FARMER'S MARKET OFFICE A Proposed 18,786 sq. ft. OFFICE BUILDING (3 floors - single phase construction)

CONDITIONAL USE PERMIT MODIFICATION OWNER CARR MILL LIMITED PARTNERSHIP

STAFF REPORT

PROJECT: Major Modification to the Conditional Use Permit for the Carr

A-2

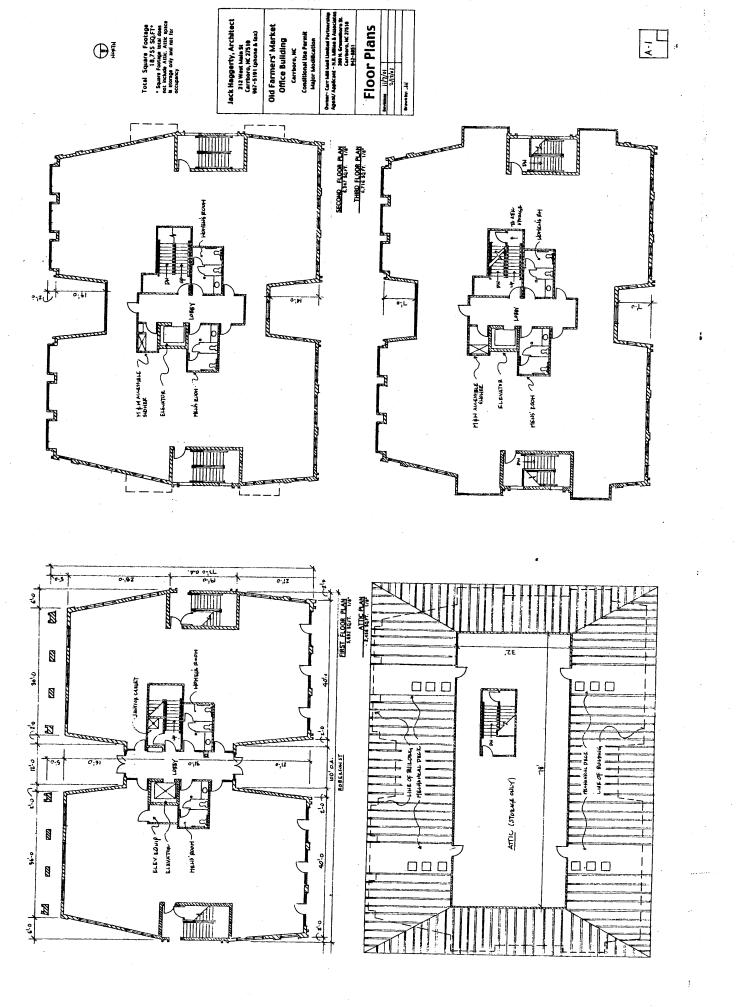
A metal roof is proposed and the façade of the building would largely consist of brick material with a large number of windows plus 'glass curtain wall systems,' which have been incorporated into the façade at various points along each wall, with the exception of the northern elevation (facing Roberson Street). The large number of windows along with the 'glass curtain wall systems' should provide a large amount of natural light within the building itself (Attachment A, PageA-2).

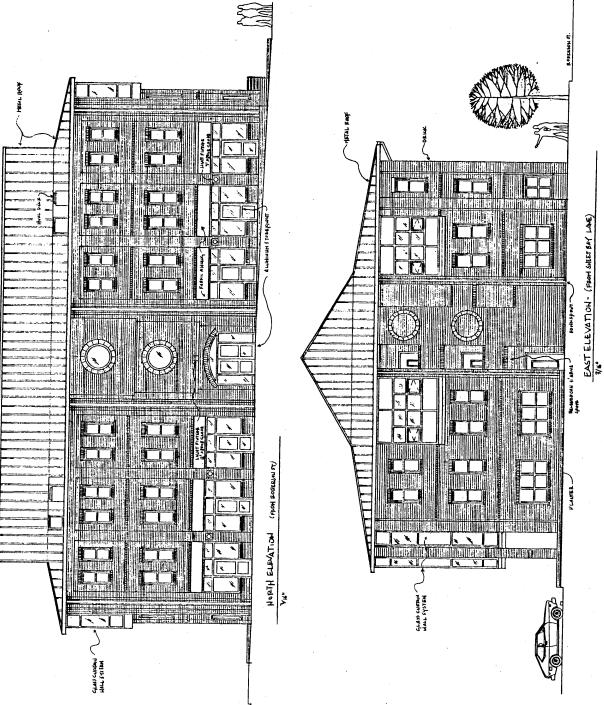
The northern elevation (facing Roberson Street) includes a fabric awning above large first-story windows, along with aluminum detailing at each of six storefront spaces along Roberson Street. Wall-mounted light fixtures are also included at nine feet (9') above ground level. Details such as these should help create a pedestrian-friendly streetscape along Roberson Street.

The central portion, when facing the building from Roberson Street or from the parking lot, is recessed, which should help break up the mass of the building (Attachment A, Page A-1). Within the recess, along the northern elevation, two large circular windows are included at the

center point, which are encircled by cast stone. The 'cast stone circles,' without the windows, are also included along the eastern and western elevations.
